## **FDA Executive Summary**

Circulatory System Devices Advisory Committee Meeting

Endologix AFX

Risk of Type III Endoleaks

*Figure 7: Graphic of Fully Deployed AFX2 with Arrows Pointing to Fabric Billowing<sup>19</sup>*

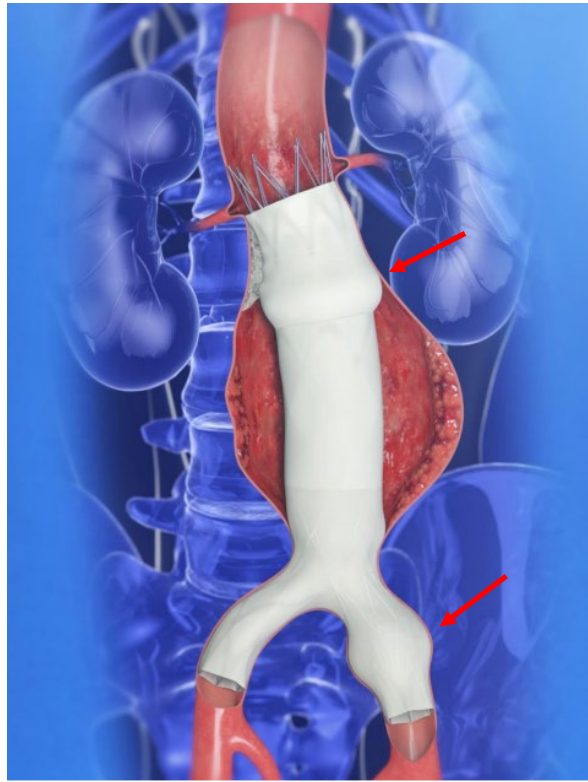
The schematic in Figure 7 shows how the unattached PTFE fabric can billow outward from the area in which the stent frame does not follow the aortic contour. This can occur in a tapered neck or in a dilated common iliac artery. Some literature reports describe billowing as a normal radiographic phenomenon, but others suggest that this finding may indicate an increased risk of aneurysm rupture.<sup>21, 22</sup>

Figure 13: Type IIIa Endoleak Complaint Trends by Product Type in 2018 Physician Letter

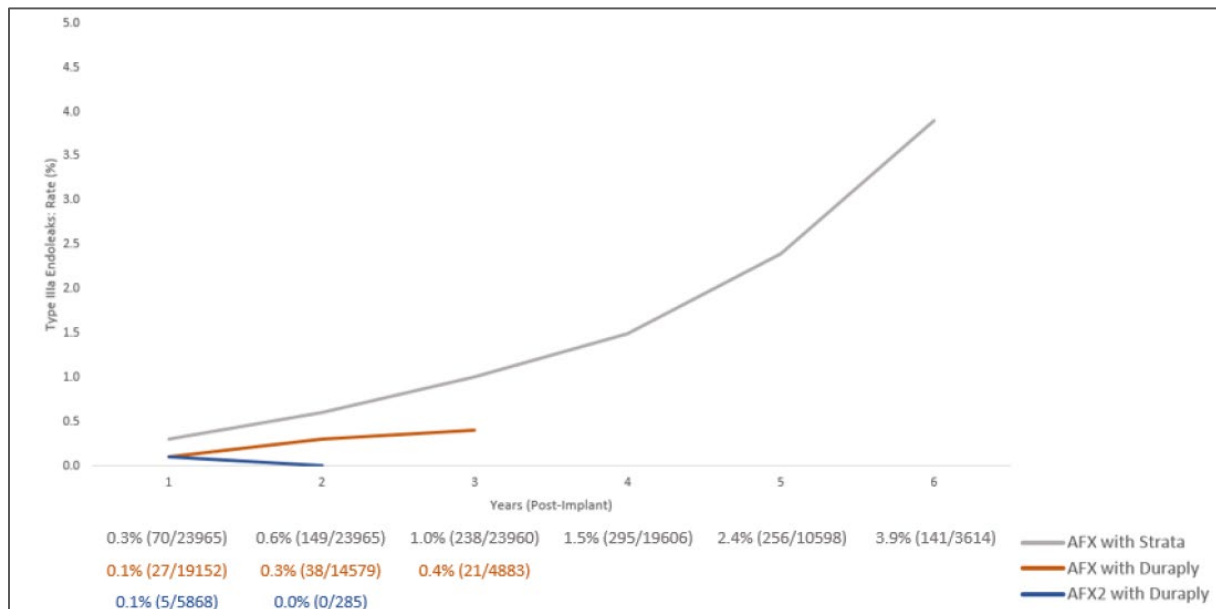
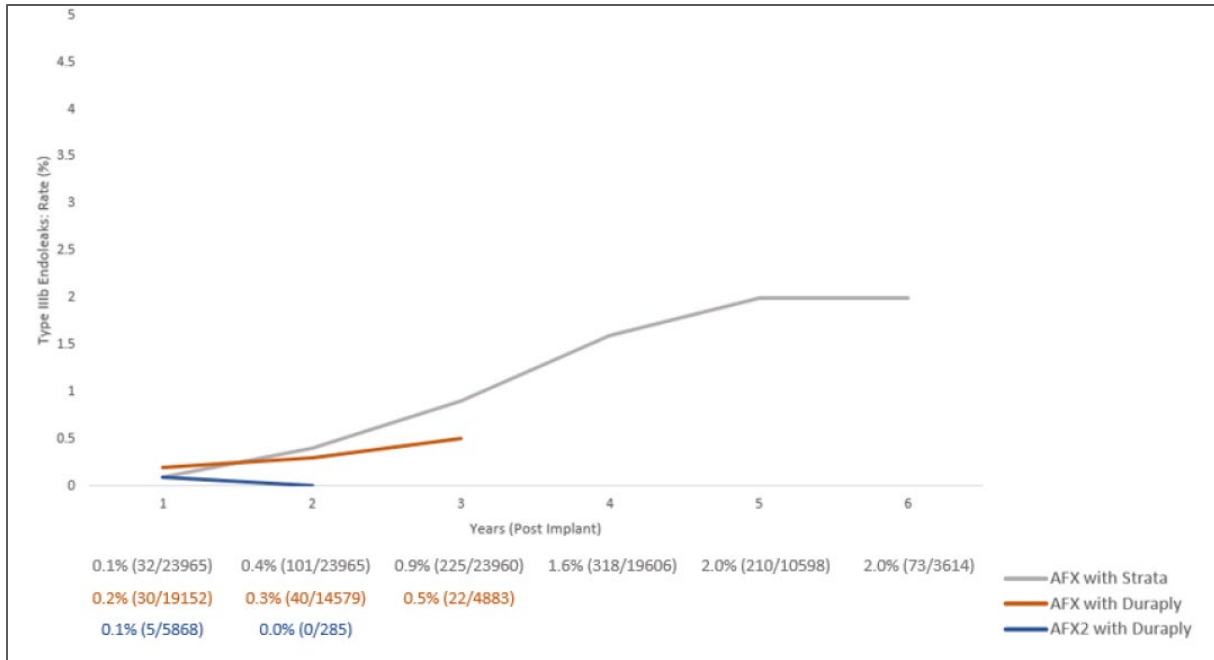
**FDA Comment:** AFX device recalls indicate a serious Type III endoleak concern. Although most data are from the AFX device versions that are no longer on the market, it is not clear if the mitigations implemented by Endologix have adequately addressed the issue for the current generation AFX2 device.

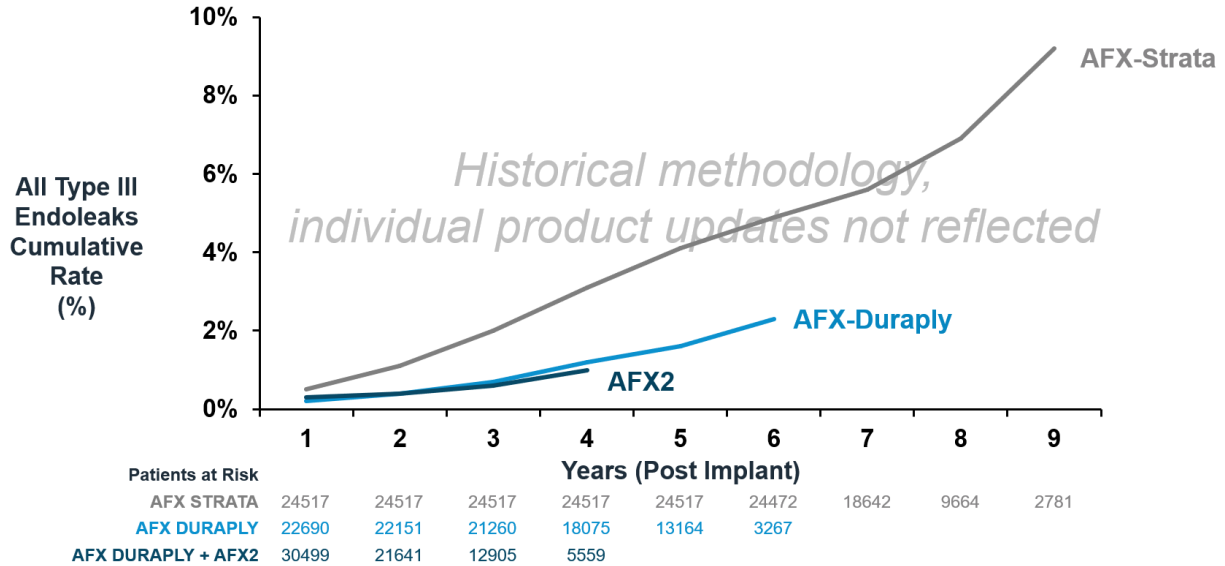
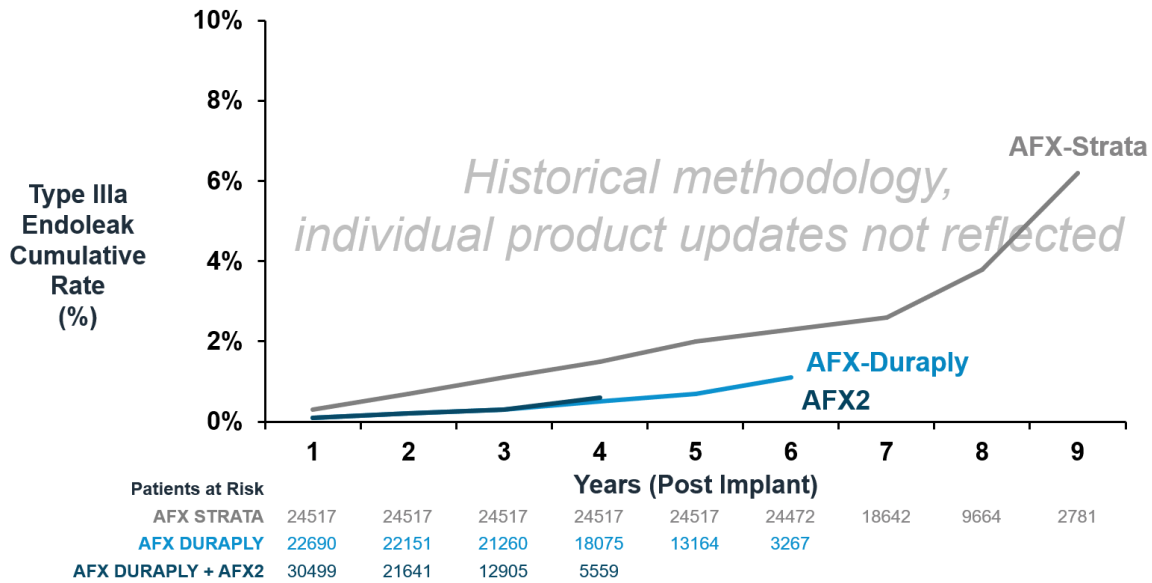
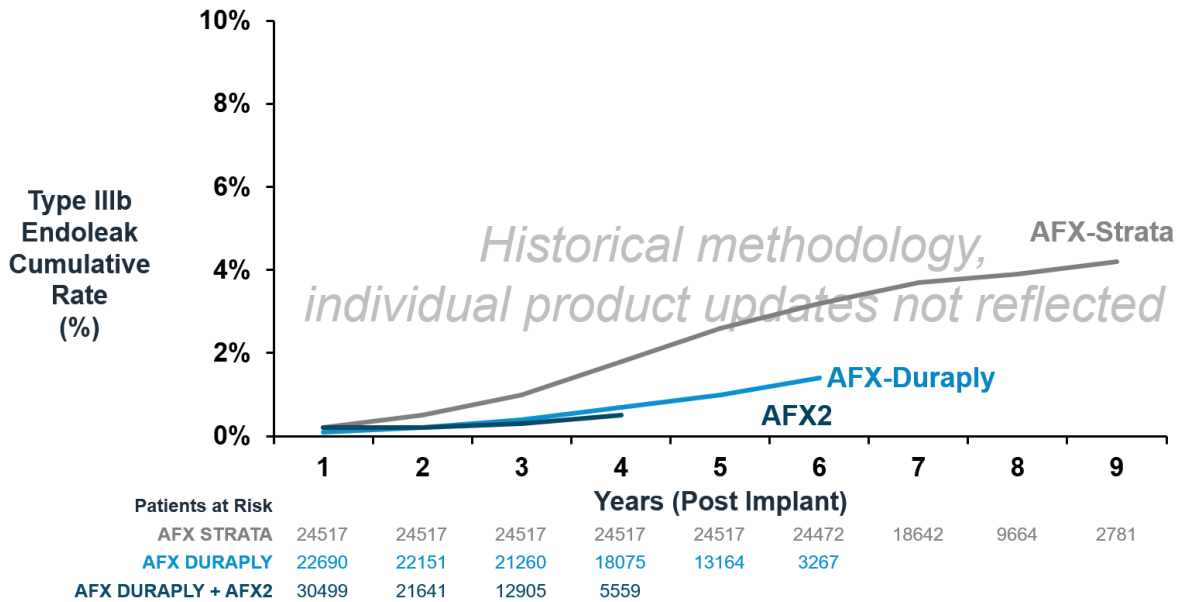
**FDA Comment:** FDA has the following comments on the additional data sources:

- *VQI Registry* – The analysis provided is based upon available 1-year data. There is a significantly higher rate of Type IIIa endoleaks for AFX with Strata/AFX with Duraply and AFX2 as compared to the rate for other endovascular grafts at one year of follow-up. Type IIIb endoleaks generally tend to occur several years after device implantation and become more frequent over time. Therefore the follow-up duration limits the ability to adequately assess Type IIIb endoleaks. These data support early concerning Type III endoleak trends for all AFX device iterations.
